SHALLOWFORD PLACE

ZONING PLAN

PETITION NO: Z-111

ZONING COMMENTS:

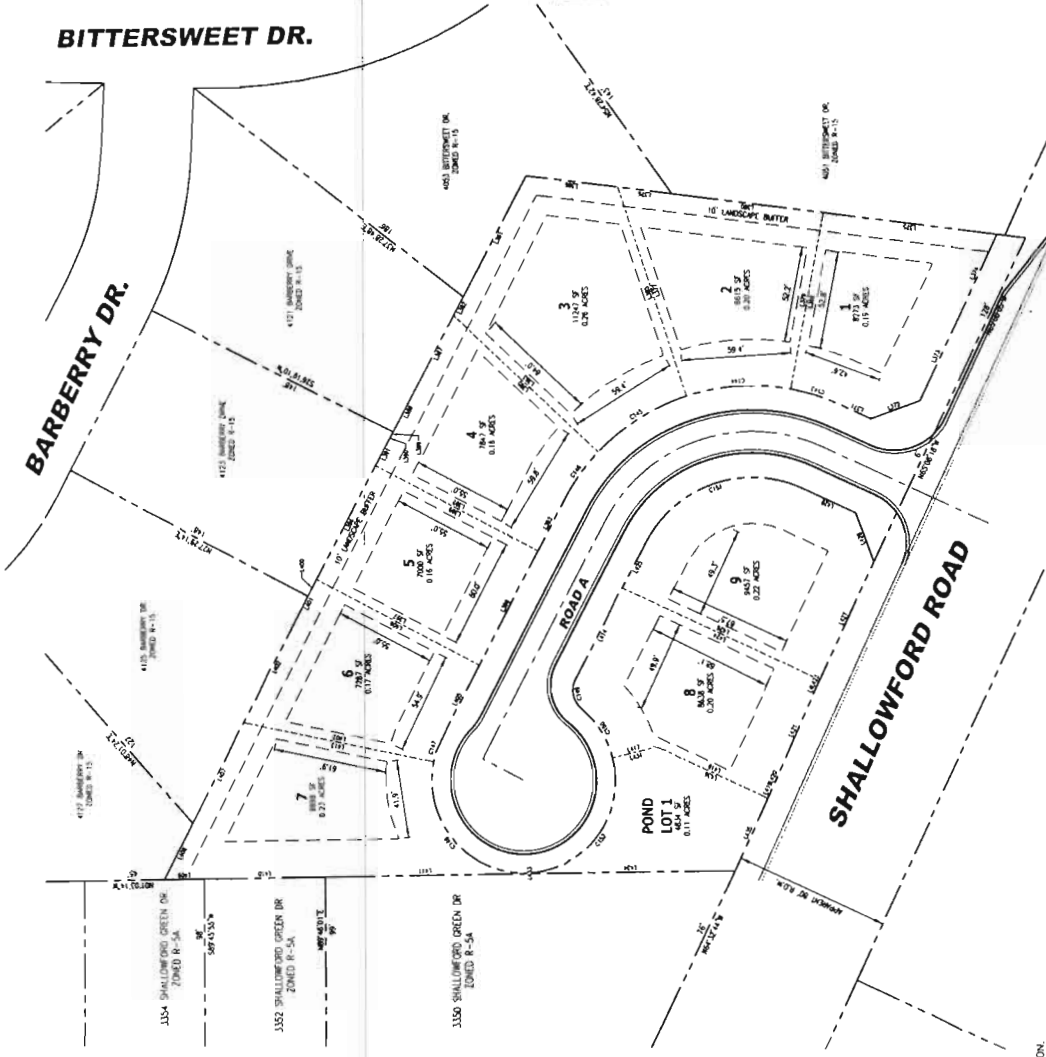
1. Waive the rear setback from the required 40 feet to 20 feet with an increase of the front setback from the required 20 feet to 25 feet.

1. This site is located just north of Shallowford Road and is bounded on the north and east by Hedgerow Subdivision and on the west by Shallowford Green Subdivision. Slopes on the site are relatively mild ranging from 2 to 10%. The majority of the site (2/3) drains to the Shallowford Road R/W. The remaining third drains to the east into the Hedgerow Subdivision Recreation Area.
2. Any bypass runoff from the rear of lots 1 through 7 must be directed to the Shallowford Road right-of-way and not to the Hedgerow Rec Area.

Shallowford Road is classified as an arterial and according to the available information the existing right-of-way does not meet the minimum requirements for this classification.

Recommend applicant consider entering into a development agreement pursuant to O.C.G.A. 36-71-13 for dedication of the following system improvements to mitigate traffic concerns: a) donation of right-of-way on the north side of Shallowford Road, a minimum of 50' from the roadway centerline.

Recommend curb and gutter along both sides and sidewalk along one side of proposed development roadway.

Recommend guest parking be located outside of the right-of-way.

1. Site plan received by Zoning Division on October 6, 2016 with District Commissioner approving minor modifications;
2. Fire Department comments and recommendations;
3. Water and Sewer Division comments and recommendations;
4. Stormwater Management Division comments and recommendations;
5. Department of Transportation comments and recommendations;
6. Owner/developer to enter into a Development Agreement pursuant to O.C.G.A. §36-71-13 for dedication of system improvements to mitigate traffic concerns; and
7. House architecture to be approved by the District Commissioner.
